# **FINAL (MYO) BASELINE MONITORING REPORT** **SIX RUNS STREAM AND WETLAND MITIGATION PROJECT**

NCDMS Project #100170  
DMS Contract #0303-01  
RFP: 16-20190303 (Issued 12/20/2019)  
USACE Action ID: SAW-2020-01964 | DWR Project #20201798 v1

RE: DMS Comments on the MY0 Report Six Runs, Project ID #100170, DMS Contract #0303-01, RFP 16-20190303

Listed below are comments provided by DMS on July 31, 2023 regarding the Six Runs Stream and Wetland Mitigation Project As-built and MY0 Baseline Monitoring Report and RES' responses.

**Six Runs**  
Sampson County, North Carolina  
78.2394°W 35.094°N

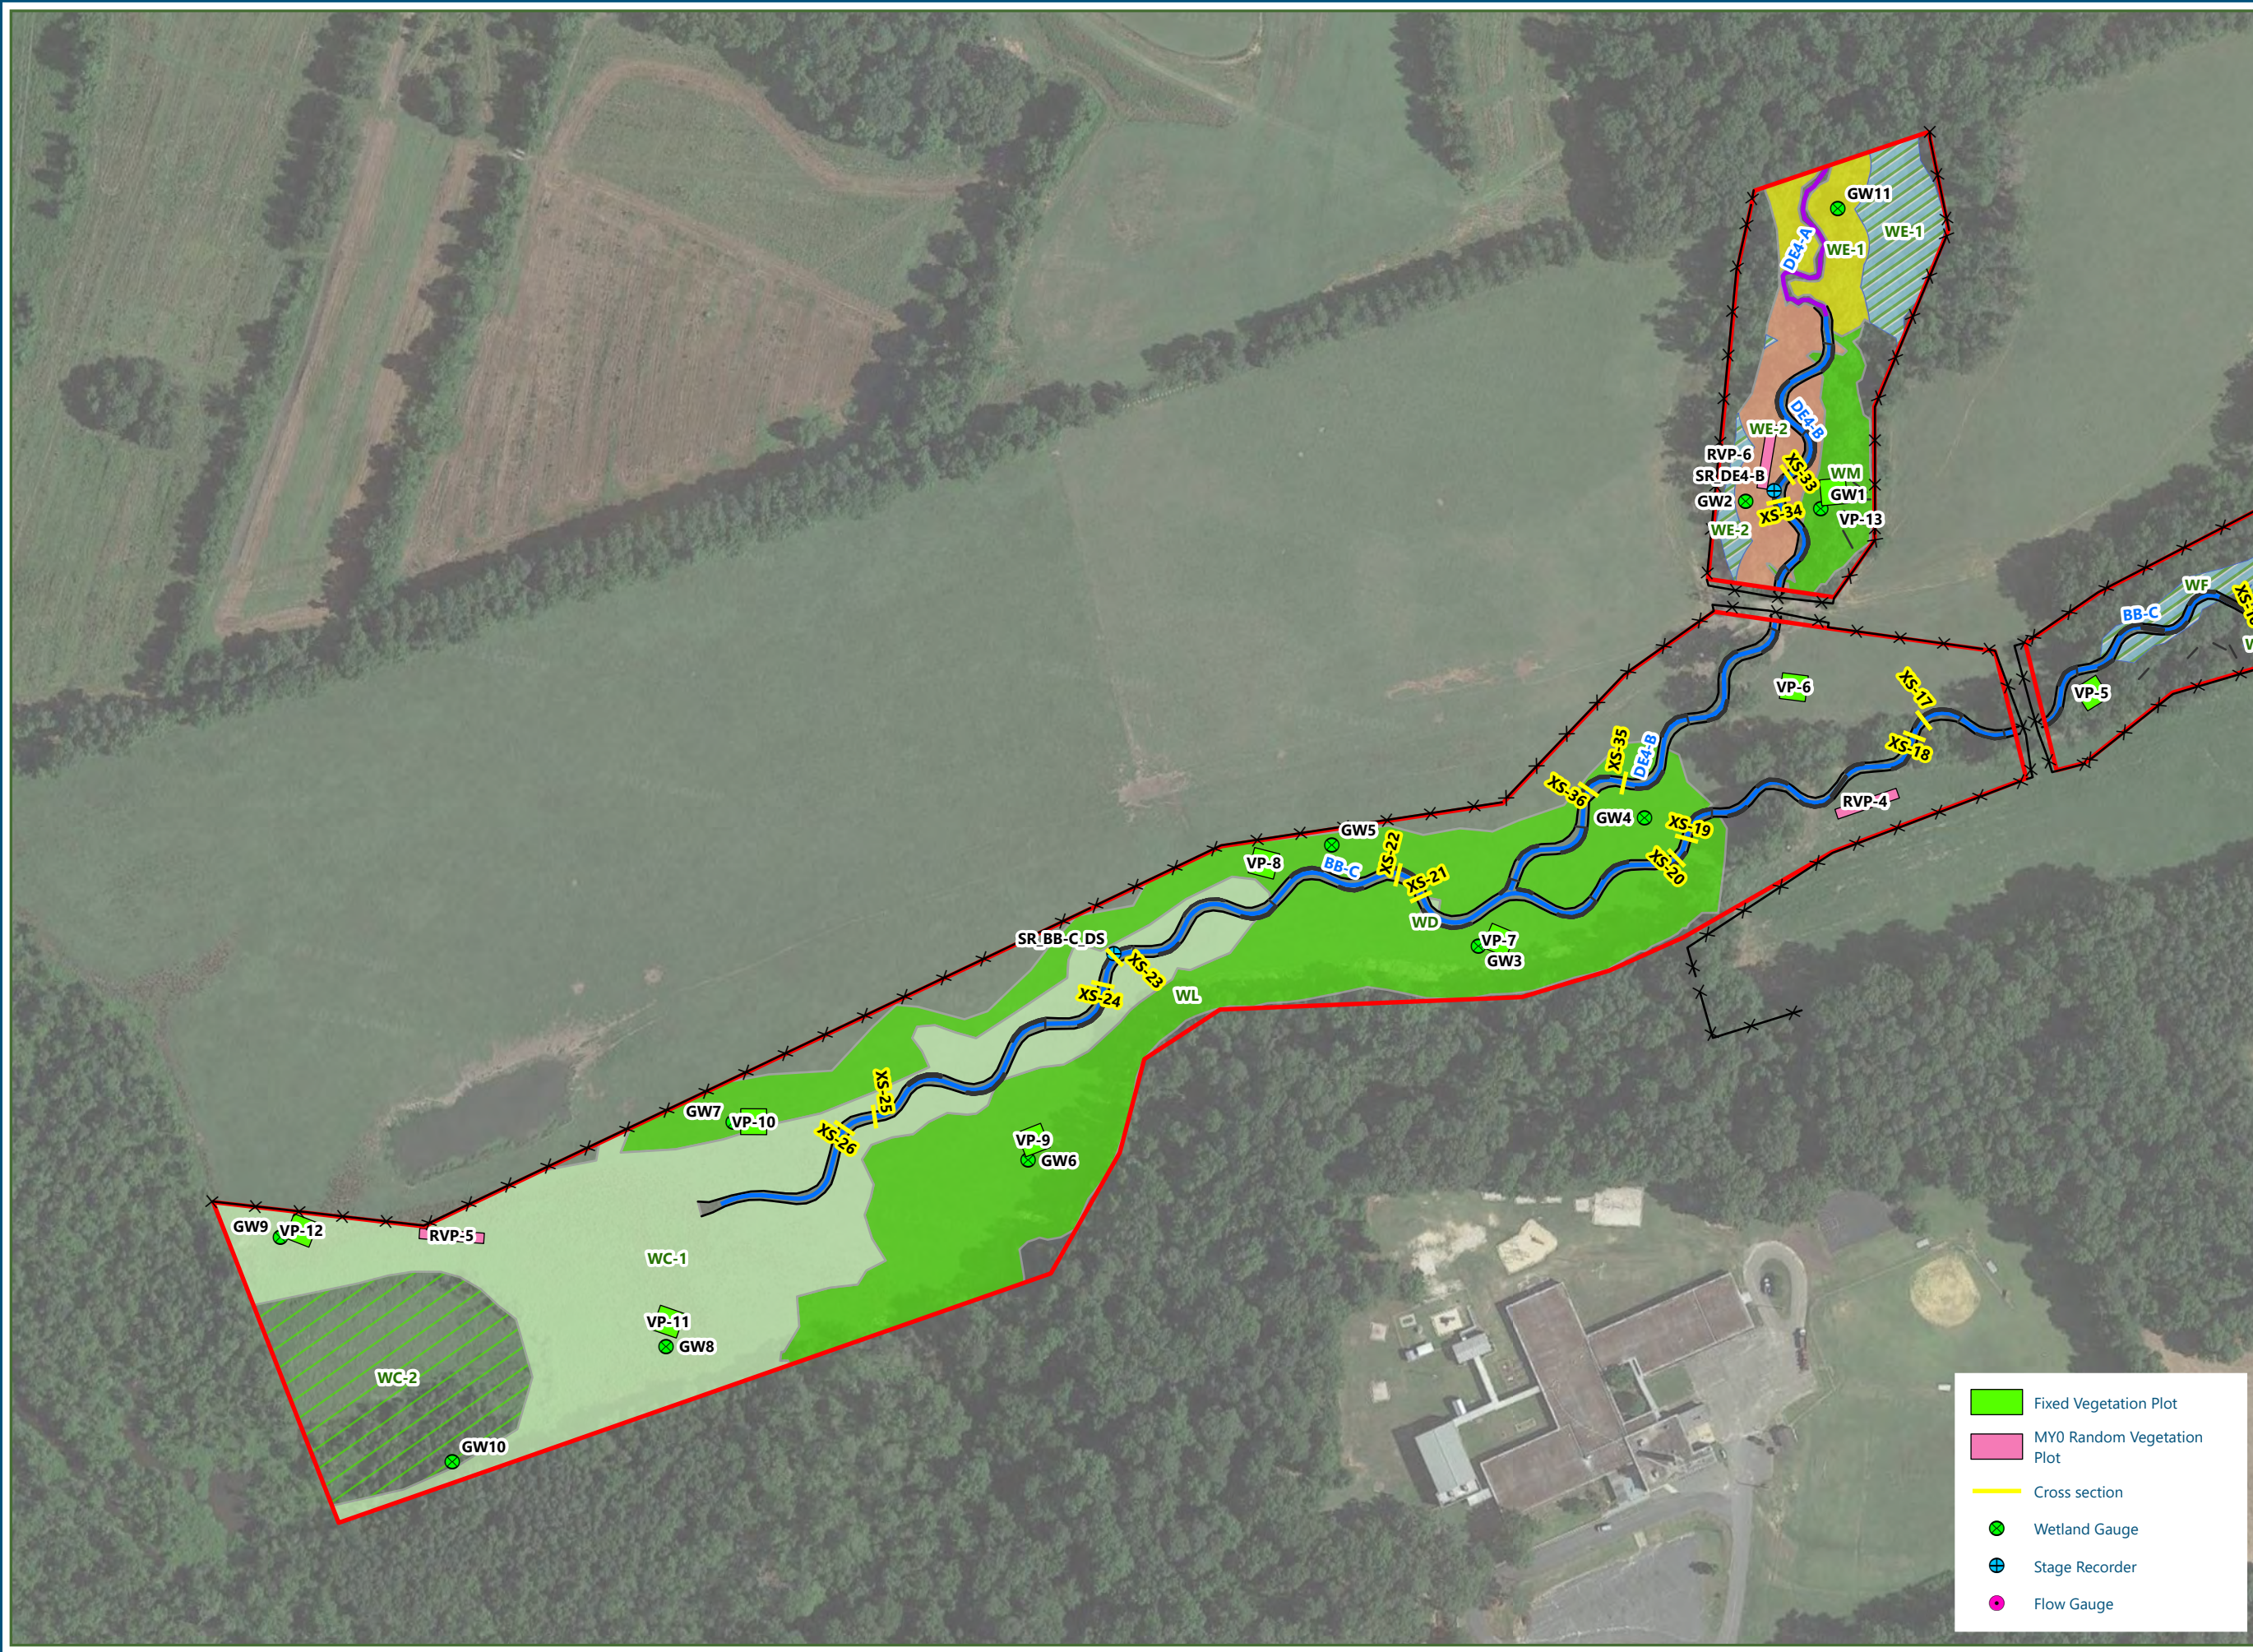
4. CCPV – We recommend re-working the cross-section labeling/line thickness so labels for cross sections 1, 3, 5, 9, and 31 are visible.  
[The cross-section labeling has been revised.](#)

SHEET NUMBER:  
**S1**

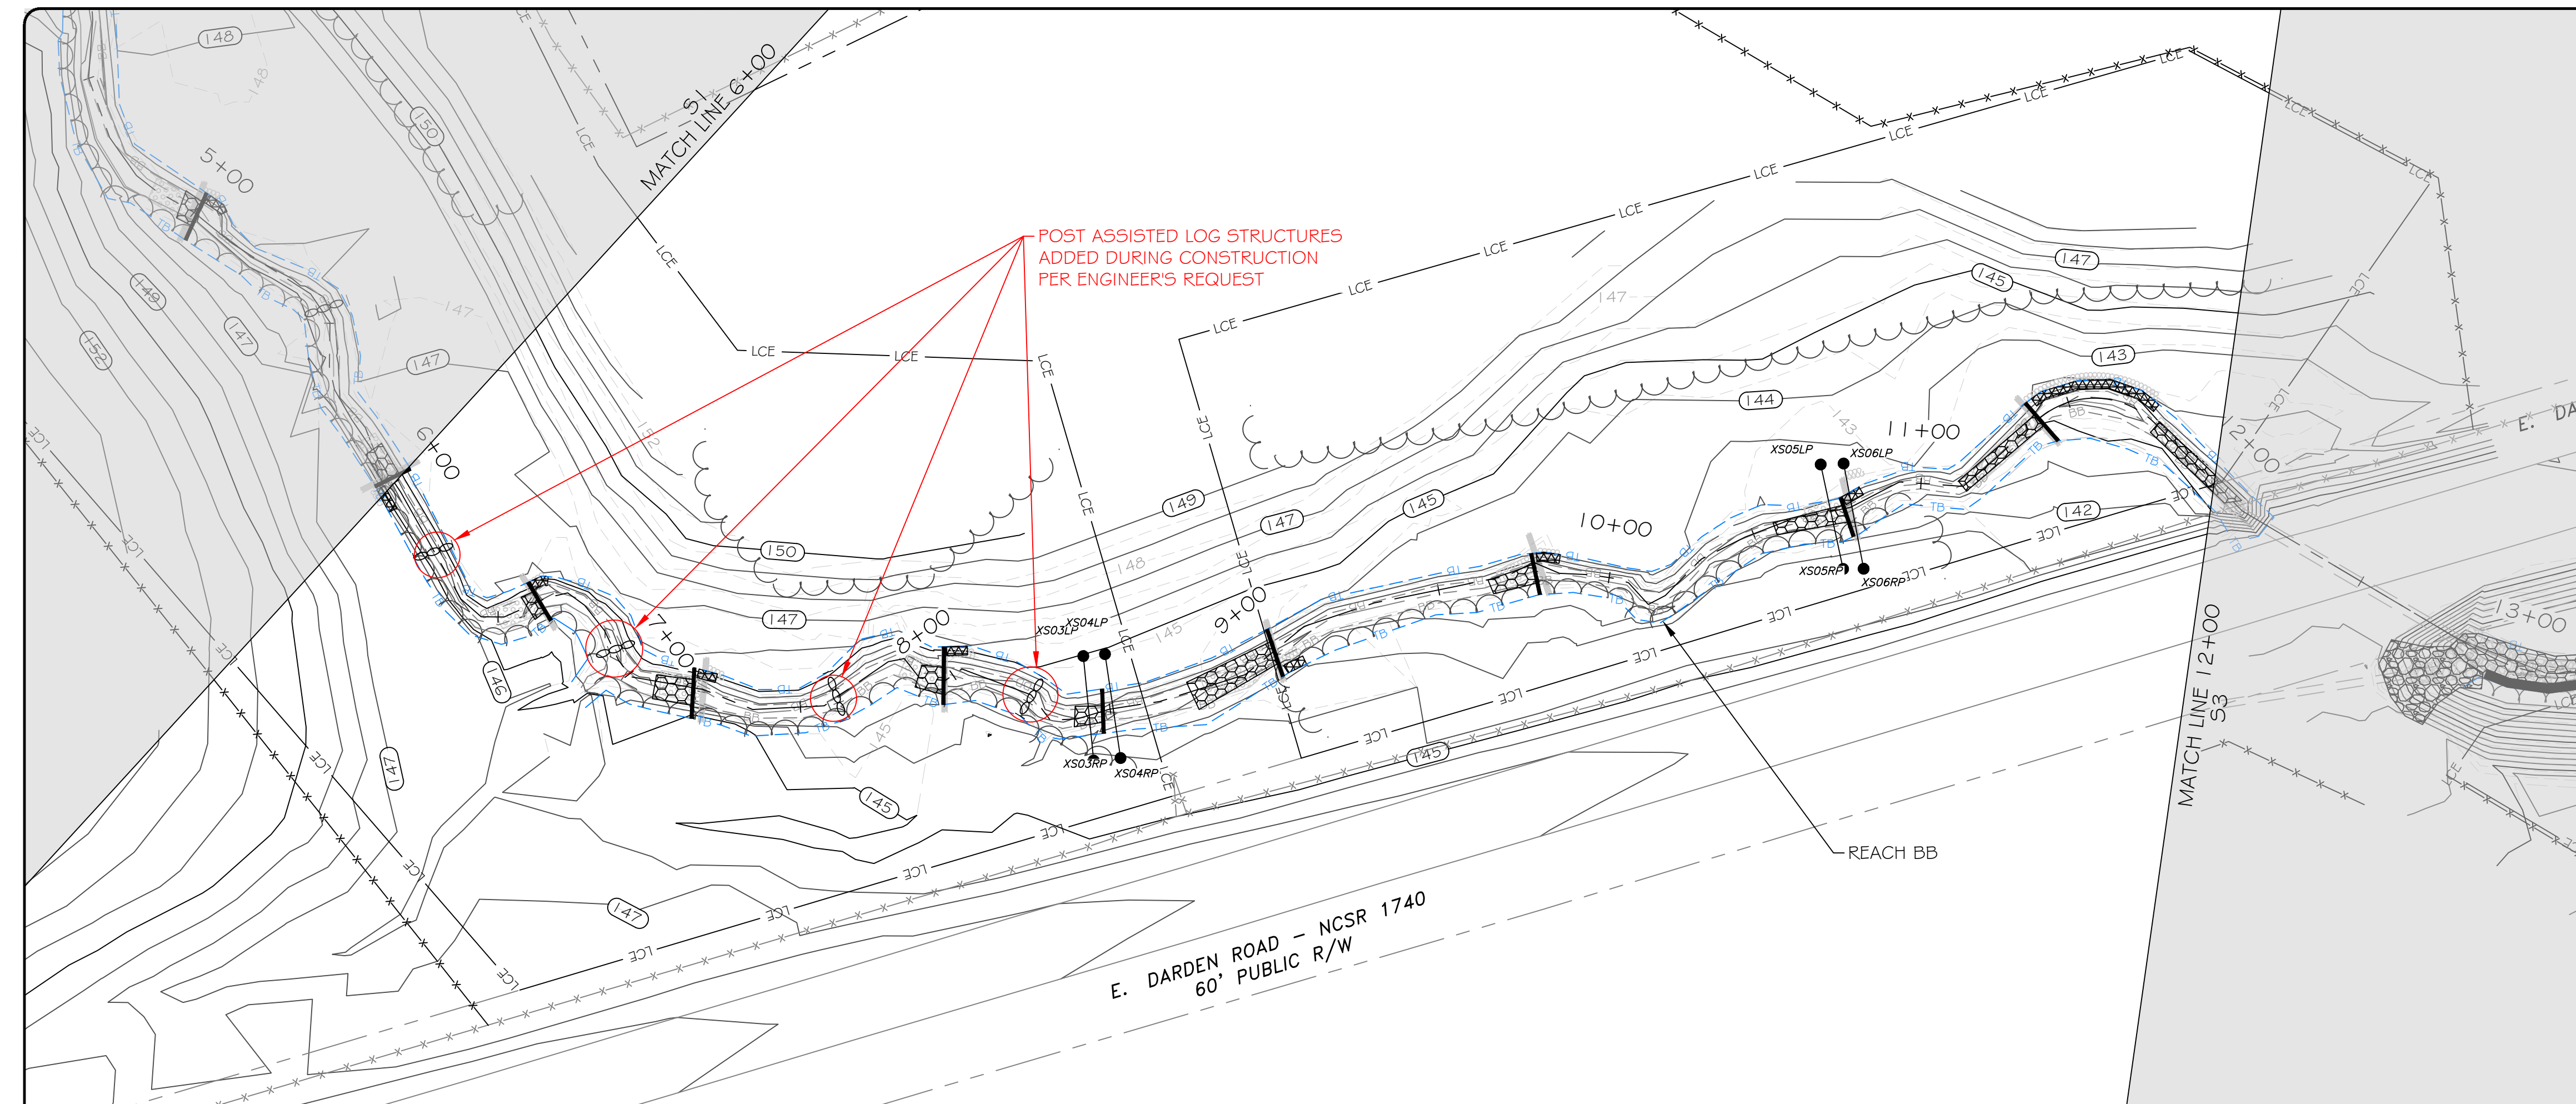
8. Please add Post Assisted Log Structure (PALS) to the Legend.  
“As-built Post Assisted Log Structure” has been added to the legend.
9. Sheet S1 – There was a PALS added between stations 5+00 and 6+00 that should receive a red callout.  
Red callout has been added for the PALS.

SHEET NUMBER:  
**S5**

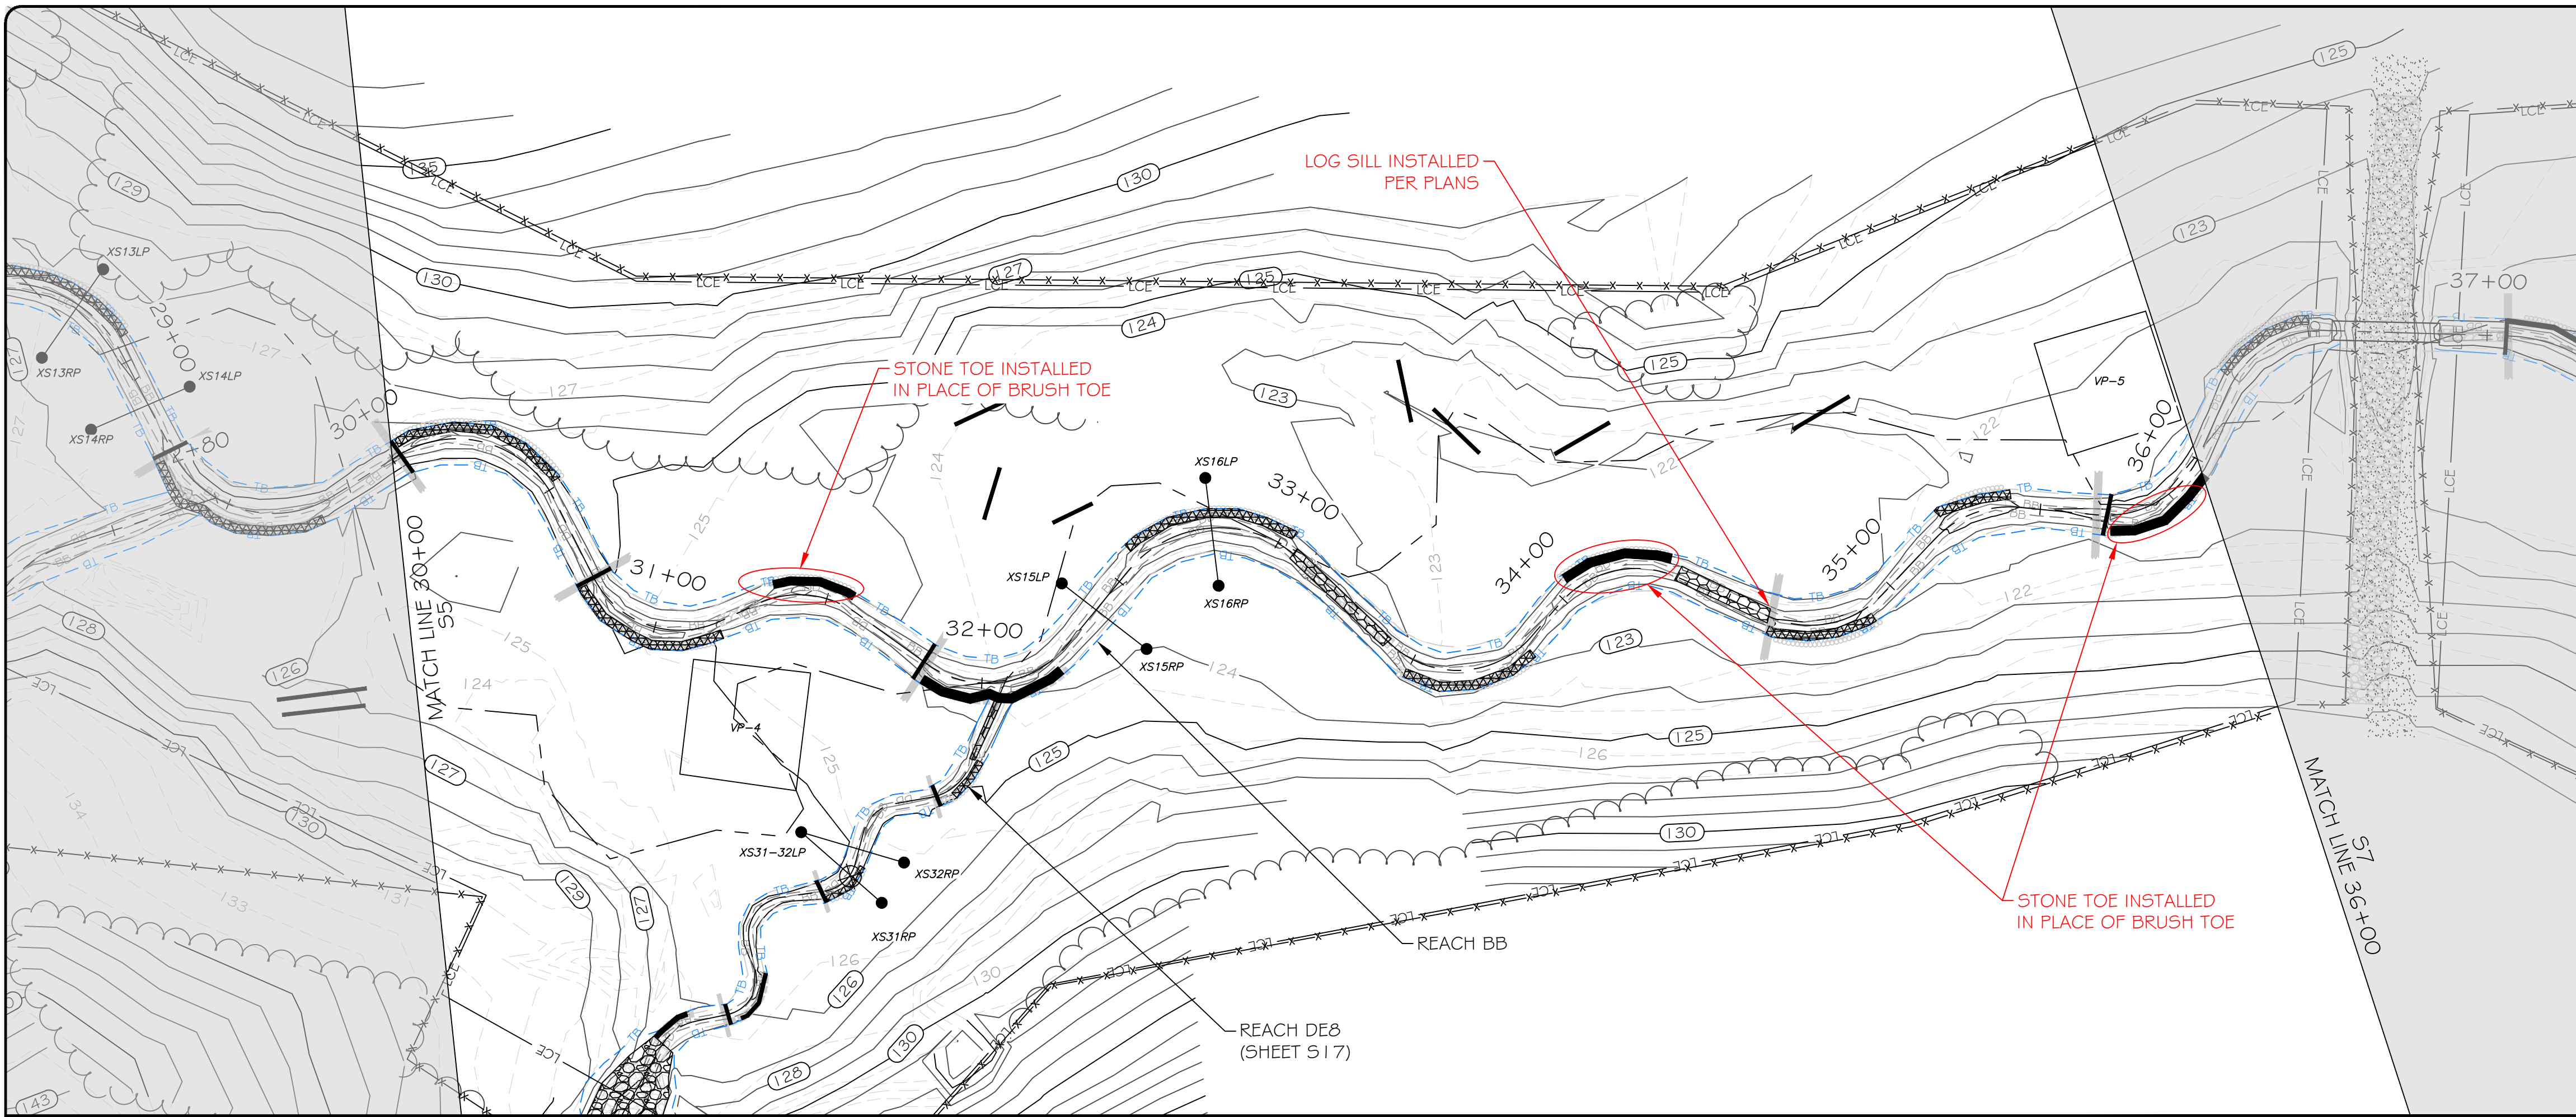
10. Sheet S5 – A stone toe was installed in place of a brush toe at the location of XS 12 and should receive a red line callout.  
Red callout has been added for the stone toe.
